Listing of PCNs

Resistors Product Change Notification

PCN Number and Title	2015-RBU14: Notice of design and process changes to LRZ Series 'High Current Jumper Chip' product manufactured in USA.		
Notification Launch Date	June 16, 2015		
Type of Change	☐ End of Life Notification ☐ Manufacturing Facility Change or Addition ☐ Datasheet Specification Change ☐ Other: <i>Qualification of Additional Ceramic Vendor</i> ☐ Material Change ☒ Process Change ☒ Design Change		
Manufacturing Location(s) Affected	Corpus Christi, TX USA	Date of Change Implementation	July 1, 2015

PCN Number	PCN-2024-RBU05 – LRZ Family Standardizing Formats
PCN Title	Datasheet Update – LRZ Family
PCN Date	18 th July 2024
Type of Change	☐ End of Life Notification ☐ Manufacturing Facility Change or Addition ☒ Datasheet Specification Change ☐ Other: ☐ Material Change ☐ Process Change ☒ Design Change
Manufacturing Location(s) Affected	TT Electronics Bedlington
Date of Change Implementation	18 th July 2024

APPENDIX 1: Details of changes to data sheet

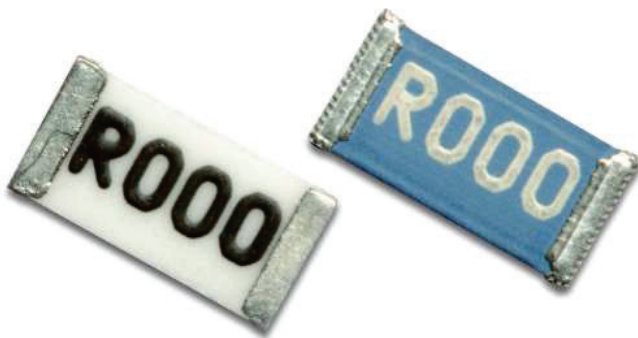
- Product Image change:
 - Before. Conventional & flip-chip format:

- After. Replace with attached (flip-chip version only):
